Hornsby Hospital Development Stage 2 Modification 4

Minor internal reconfigurations and changes to façades
State Significant Development Modification Assessment
(SSD-8647-Mod-4)

November 2020

Published by the NSW Department of Planning, Industry and Environment

Figure 3 | Approved southern elevation (above) and proposed southern elevation (below) (Source: SSD 8647 Approved Plans and Applicant’s Modification Report)

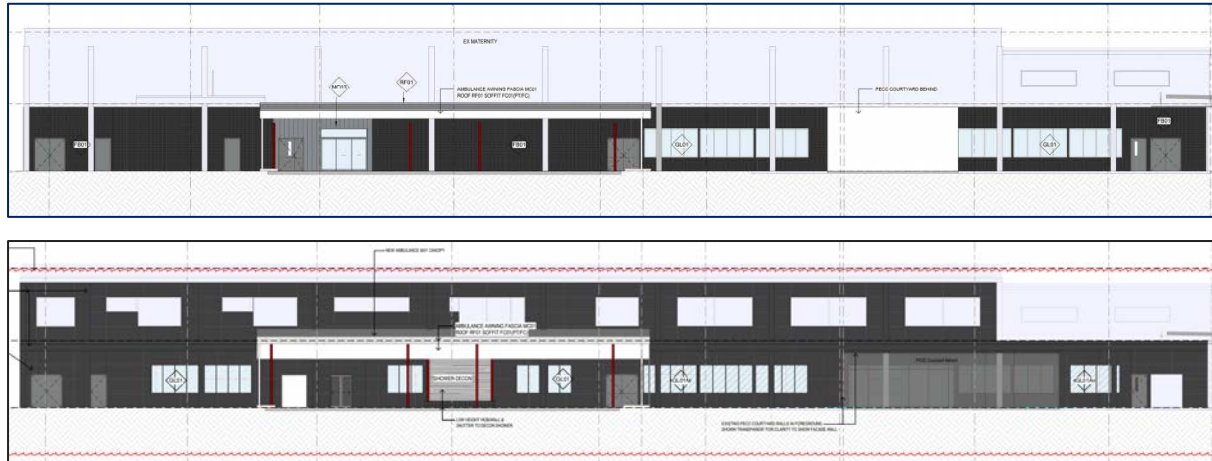
The internal changes now sought to the ED and PECC have resulted in the need for some of the external alterations to building facades, particularly in relation to door and window openings. The repositioning of windows along some elevations has been balanced by the retention of glazing in other areas, to ensure the provision of amenity for users of the hospital.

The Department understands a darker finish is proposed for some façade elements, which will not impact the building mass, height and form of the development as previously approved (see **Figures 3 and 4**).

The minor changes in the appearance of the façades will not change the building height or mass and will not impact on the visual amenity of the hospital campus to both users of the hospital and surrounding residents. The Department is satisfied that the façades will still comprise articulated elements and interest, and allow for improved internal amenity to patients. The proposed changes are therefore supported.

Figure 5 | Approved western elevation (ED) (above) and proposed western elevation (ED) (below) (Source: SSD 8647 Approved Plans and Applicant’s Modification Report)

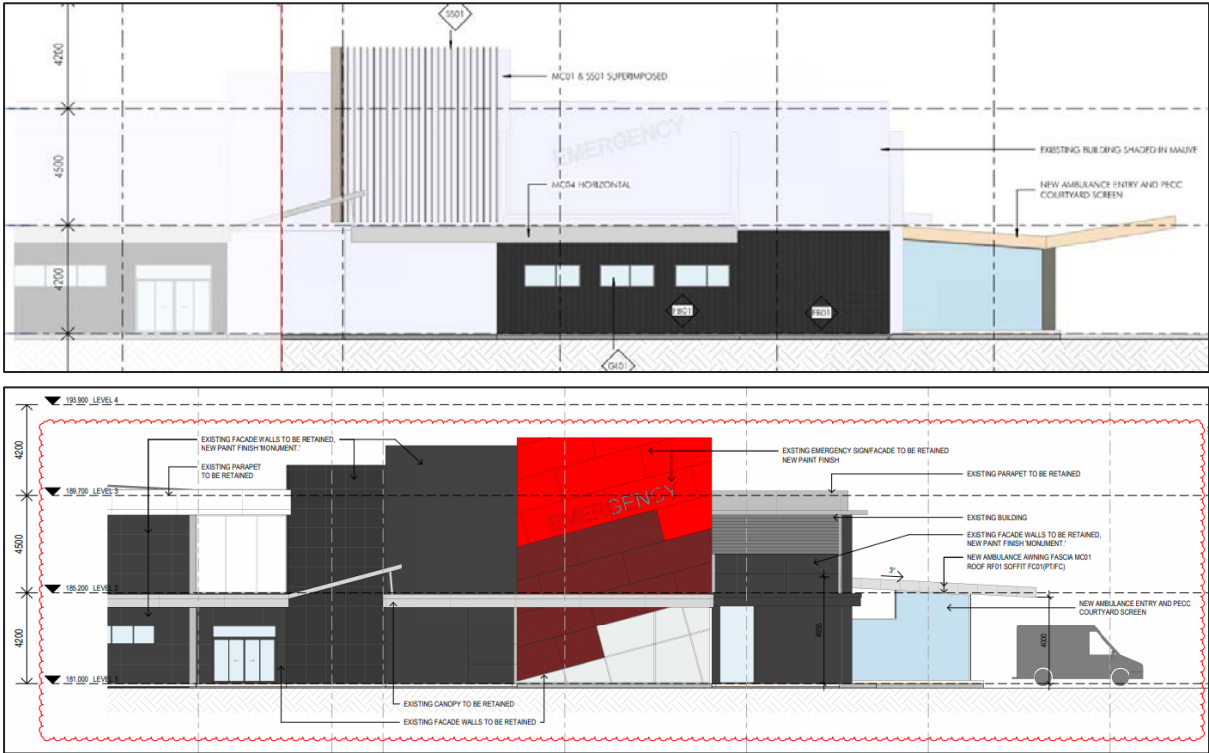
Enhancements are also proposed to the existing ED signage (rather than total replacement, as was proposed in the original approval), including a new paint finish, however the approved size and dimensions are retained (see **Figure 5**, with the signage shown on the red panel). The proposed new ambulance awning and courtyard screen can also be seen on the right hand side of the elevations.

Figure 6 | Proposed ambulance awning (Source: Applicant's Modification Report)

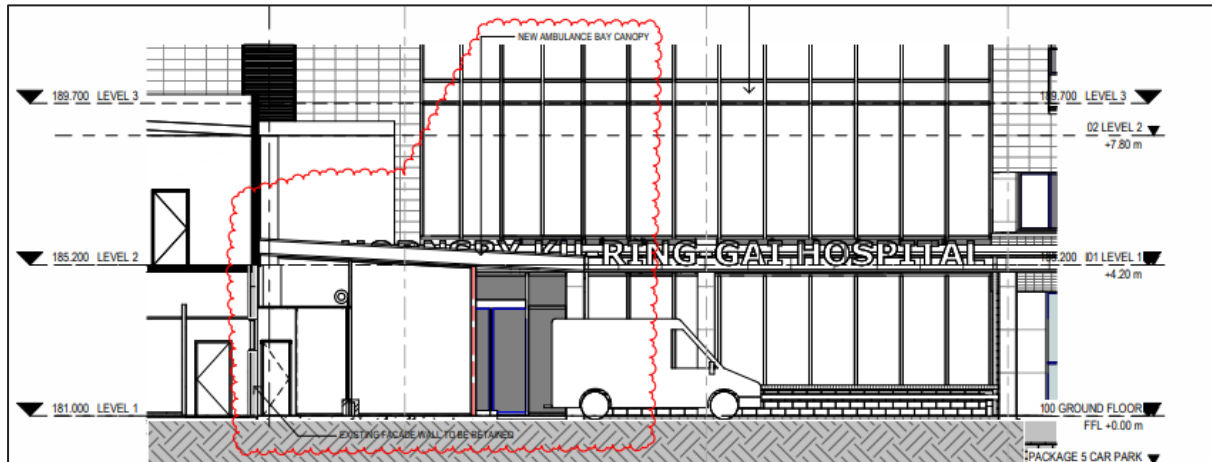
The modification application proposes a revised awning and screening to provide privacy for patients (see **Figures 5 and 6**).

The Department is satisfied that the proposed change to the awning design will not result in any adverse visual or amenity impacts and the revised design is therefore supported. The courtyard screen will also provide necessary private for patients within the courtyard area.

Figure 7 | Proposed external decontamination shower facility plan (above) and south elevation (below) (Source: Applicant’s Modification Report)

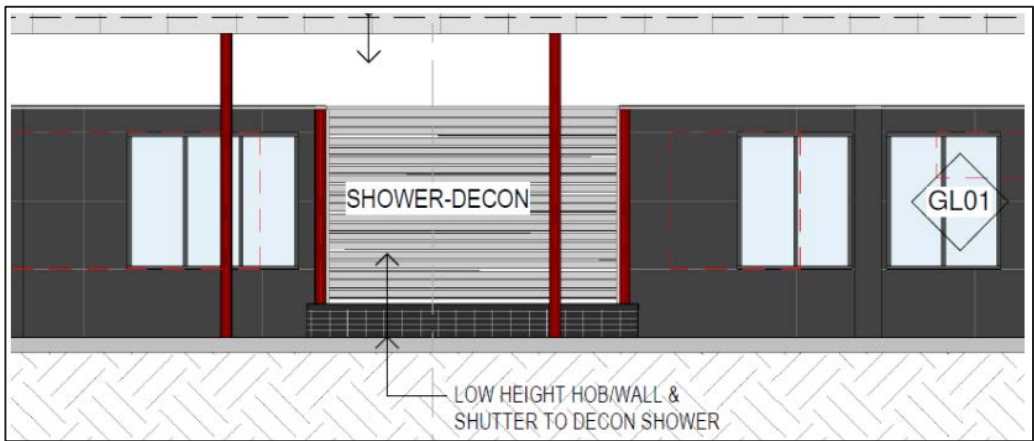
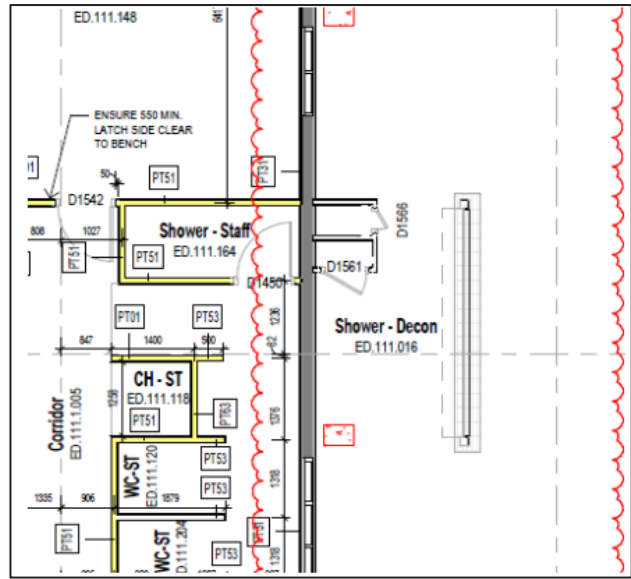
The existing Stage 3 approval includes a decontamination shower within the ED. This modification seeks to relocate the decontamination shower externally to the ED (see **Figure 7**). The Department understands the change is a result of consultation with user groups to improve the operational use of both the shower and the ED.

The modification as proposed will provide increased user amenity and allow for an improved use of space within the ED. The Department is therefore supportive of the proposed change.

Figure 8 | Approved balustrading (above) and proposed balustrading (below) (Source: SSD 8647 MOD 3 Approved Plans and Applicant’s Modification Report)

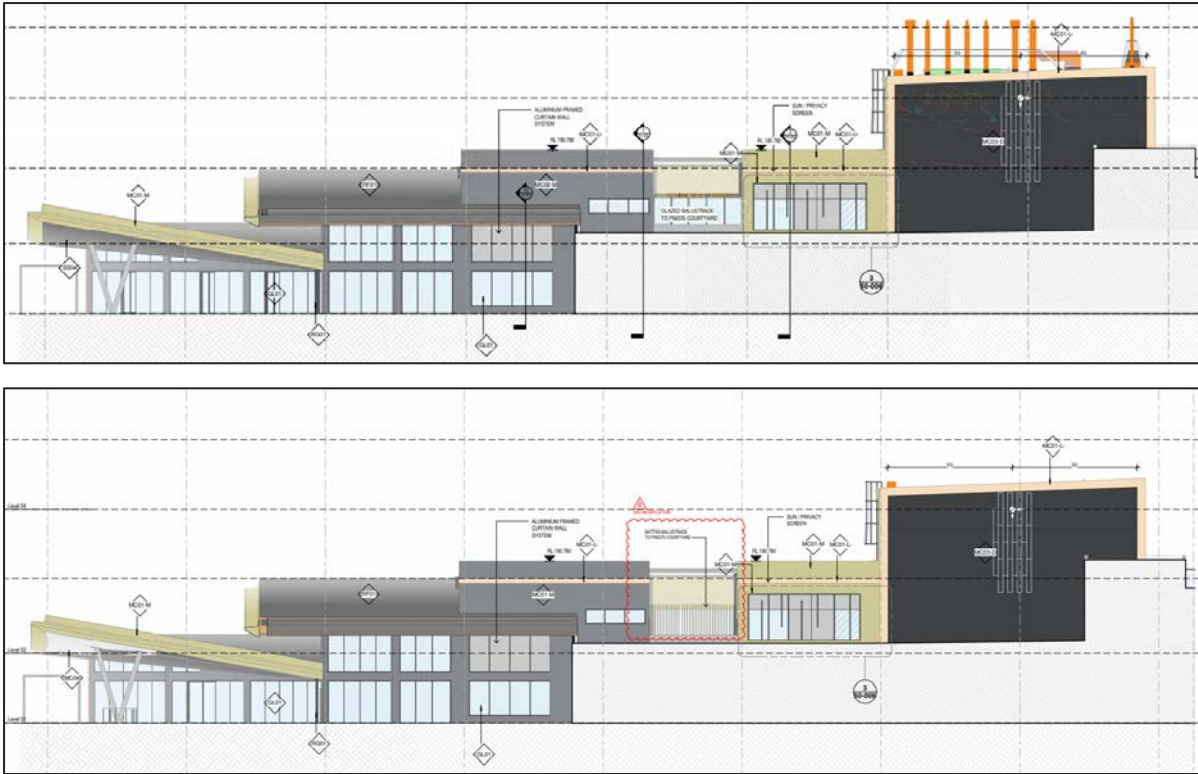
The modification application proposes to revise the balustrading to the Paediatric courtyard from glazed to batten balustrading (see **Figure 8**). The Department understands that this change is required to allow for the safe flow of down thrust from helicopters during departure from the helipad above. The Applicant has advised the amended balustrade will be 1.8m in height and will not compromise the safety of the staff or patients. The Department is satisfied the modification is appropriate.
